Reworld Essex Company
183 Raymond Boulevard
Newark, NJ 07105

February 13, 2026

On behalf of Reworld Essex Company (formerly Covanta Essex Company), please find attached to this submittal the updated AO-25 Response to Comments documents in Portuguese and Spanish prepared by Reworld to provide responses to NJDEP comments received in October, 2024 on the original Response to Comments document submitted in February 2024. Please note that due to the size of attachments that include comments received from the public and other information, the attachments have not been translated. Please let me know if you have any questions or comments on these documents. Thank you.

Sob a orientação do Escritório de Licenciamento e Navegação de Projetos (OPPN) do Departamento de Proteção Ambiental de Nova Jersey (NJDEP), a Covanta Essex (Unidade de Recuperação de Recursos do Condado de Essex/ECRRF) realizou uma audiência pública virtual em 16 de novembro de 2022 e recebeu comentários durante o período de consulta pública, que teve início em 16 de setembro de 2022 e término em 16 de dezembro de 2022. A audiência pública e o período de consulta pública visavam atender aos requisitos da Ordem Administrat

Figure 3-1 Location of the Covanta Essex County Resource Recovery Facility

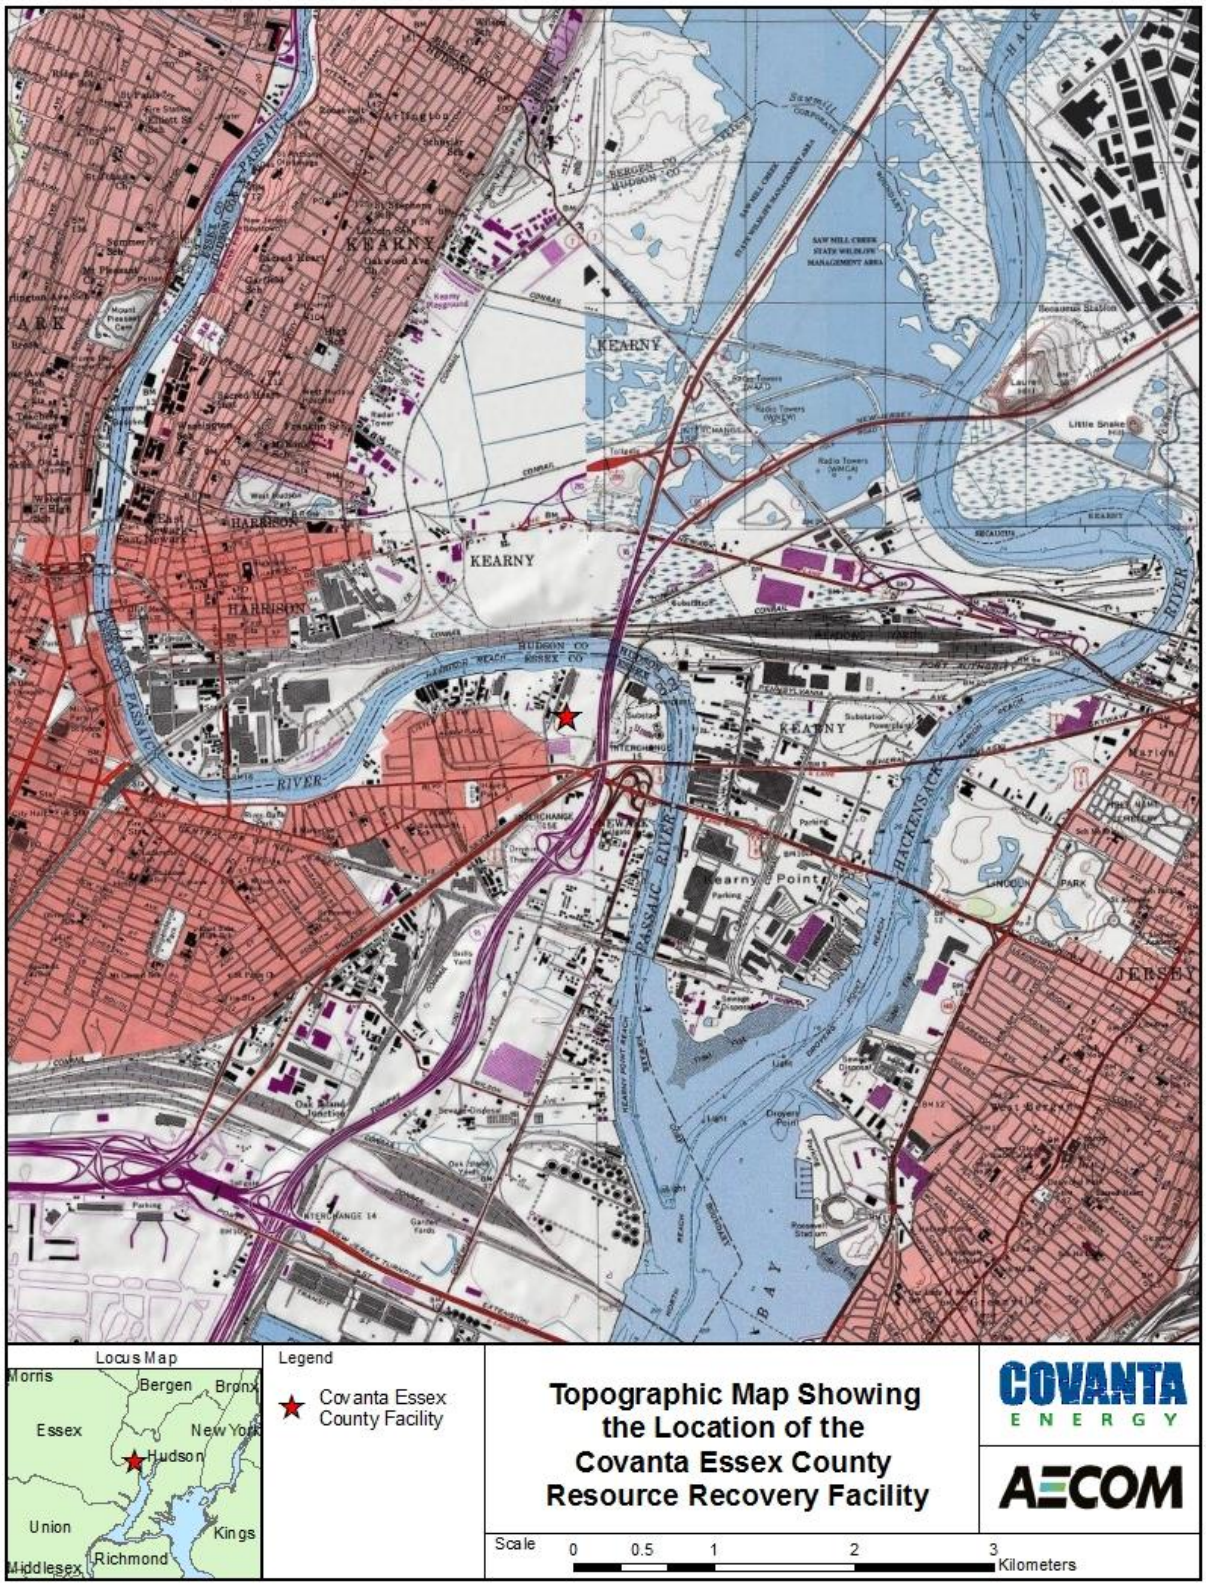
2. This section referred Figure 3-1 twice as Figure 2-1.
